DESCRIPTIVE REPORT

Registry No. H-10944

General Locality Eastern Tracy Arm

Descriptive Report to Accompany Hydrographic Survey H10944

ROCK FROM PRIOR SURVEY H09480

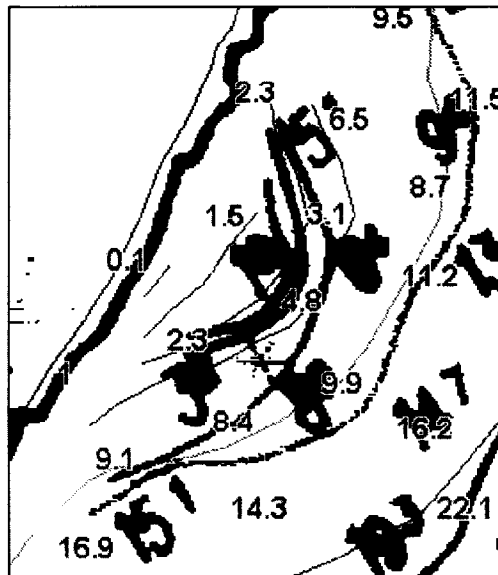
- 2. **Description and Source of Item:** Rock on prior surveys H09480 and H10758 (brought through from prior survey H09480). It is worth mentioning that the Hydrographic Survey Inspection Team Report (May 26, 1976) for survey H09480 stated that there was no detached positional data to substantiate the existence of this rock, but it was included on the survey in the interest of conservatism and safety.

- 5. **Results of Investigation:** No rock was found at this location. However, there is a shoal area that extends from shore in the vicinity of the rock. Current soundings reveal depths between 5 and 10 fathoms at the position of the rock.

- 6. **Comparison with Prior Surveys:** See above.
- 7. **Comparison with the Chart and Charting Recommendation:** Compared with chart 17300; 28th Ed.; September 12, 1998, 1:209,978. The chart shows a rock located at 57°53'42"N, 133°11'12"W. The Hydrographer recommends removing the rock from chart 17300, and charting depths from this survey on charts 17300 and 17311. *Concur*

23-FATHOM SOUNDING FROM H10758

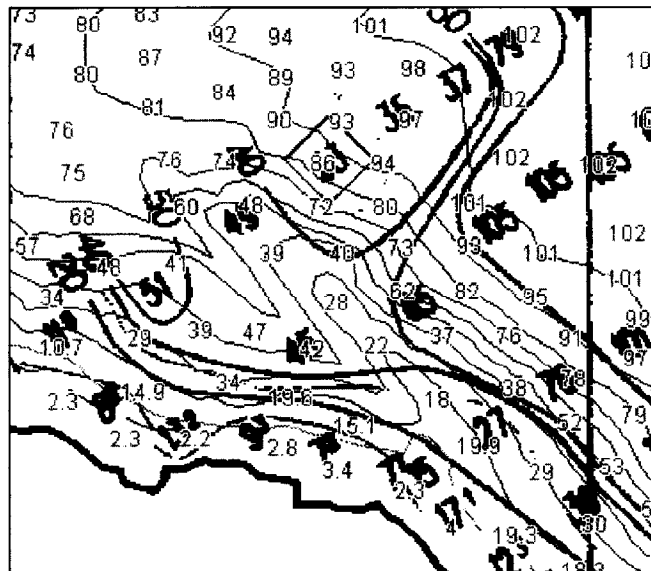
2. **Description and Source of Item:** 23-fathom sounding on prior survey H10758. This sounding is significantly shoaler than those in the surrounding area.

5. **Results of Investigation:** Current soundings show the depth to be 86 fathoms at this location. However, soundings from 100% SWMB coverage revealed a ridge 100 meters to the south which trends NW-SE and have minimum depths between 28 and 48 fathoms.

6. **Comparison with Prior Survey H09480:** No shoal area is found at this location. The 23-fathom sounding lies 50m ESE of a 68-fathom sounding on survey H09480.

7. **Comparison with the Chart and Charting Recommendation:** Compared with chart 17300; 28th Ed.; September 12, 1998, 1:209,978. The chart shows a sounding of 64 fathoms in the vicinity of the 23-fathom sounding on prior survey H10758. This charted sounding exists over a moraine for which the current survey shows the minimum depth to be 59 fathoms. The Hydrographer recommends charting depths from this survey on charts 17300 and 17311. *Concur*

29-FATHOM SOUNDING FROM H10758

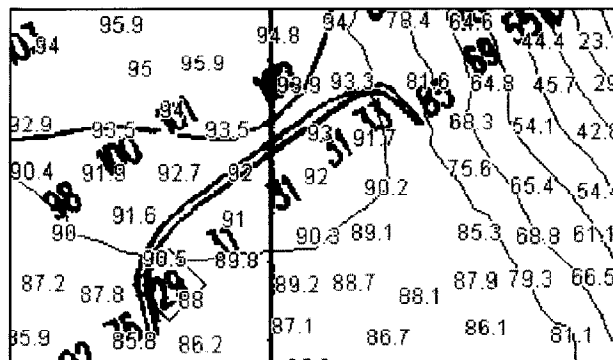
- 2. Description and Source of Item:** 29-fathom sounding on prior survey H10758. This sounding is significantly shoaler than those in the surrounding area.

- 5. Results of Investigation:** No shoal area was found at this location. Current soundings reveal an area that is flat and deep (90 fathoms).
- 6. Comparison with Prior Surveys:** See Above. This item is beyond the limits of survey H09480

- 7. Comparison with the Chart and Charting Recommendation:** Compared with chart 17300; 28th Ed.; September 12, 1998, 1:209,978. This location lies outside the area covered by chart 17300 and there is no chart covering the adjoining area to the east. In addition, chart 17300 shows the extent of South Sawyer Glacier to be significantly seaward of its present location, implicitly covering this location. The Hydrographer recommends extending the area covered by chart 17300, and charting depths from this survey on charts 17300 and 17311. *Concur*
